Reactive Power Capability

Example - anonymised

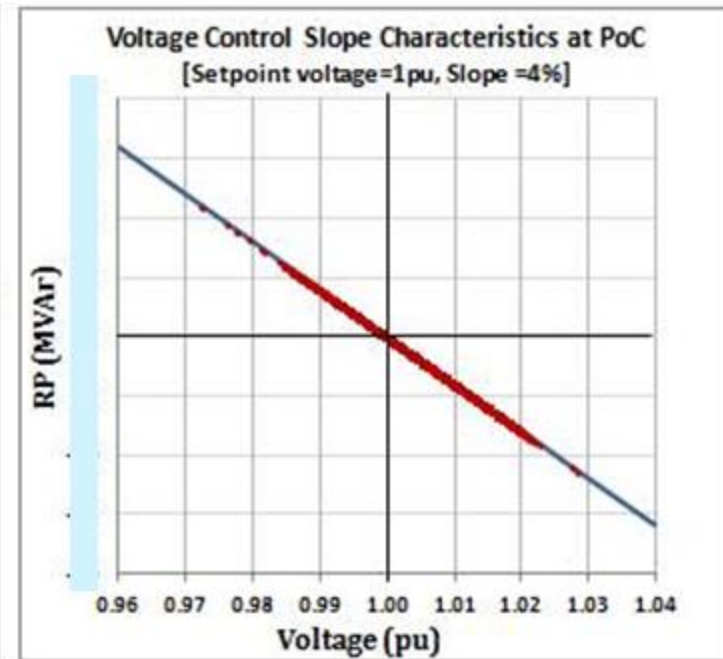
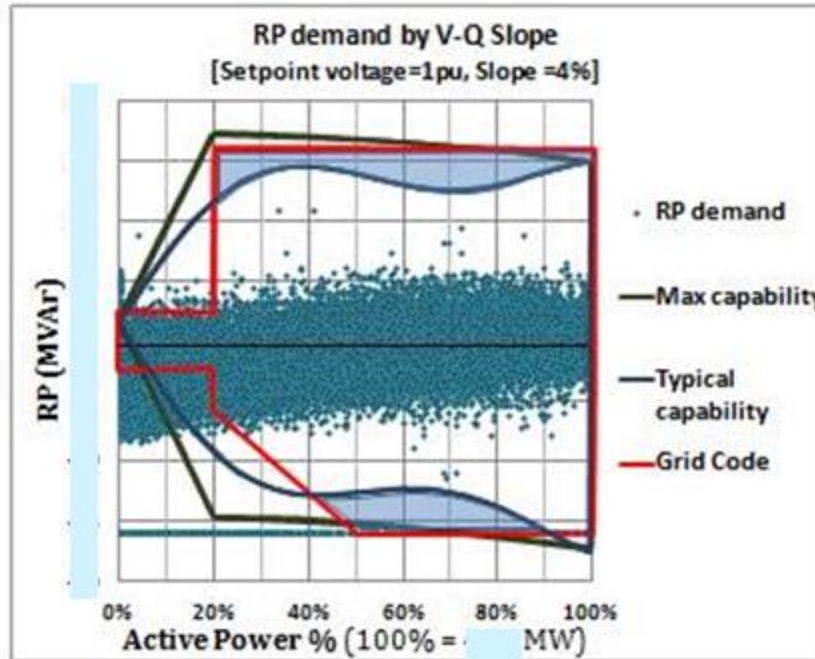
+£..m.
1. Symmetric RP - necessary?

2. representative?

< with *all* units running

< realistic (X% confidence)

Would like to understand NG's need for perfectly symmetrical RP capability, and need to badge performance at PoC (or indeed HV side of trafo if in Scotland) rather than turbine terminals. Could be instances where GC drives individual connecting party to install a Statcom but this is not most efficient design for overall system.

voltage control

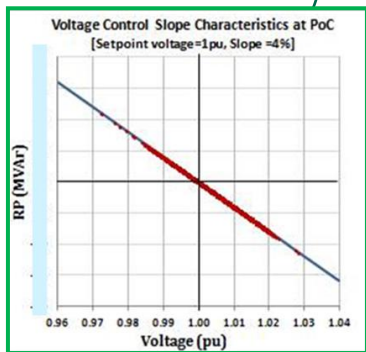
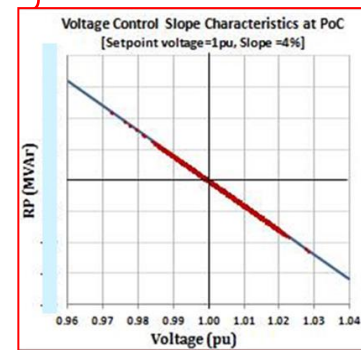
-£k...100's.
3. Why not at Unit?

stable when paralleled

power station with multiple generator units – e.g. power park modules – could provide voltage control slope at *LV terminals* of each unit rather than PoC, and *at lower cost*. Would this materially detriment TSO operation? if acceptable, this would deliver lower cost generation for consumer.
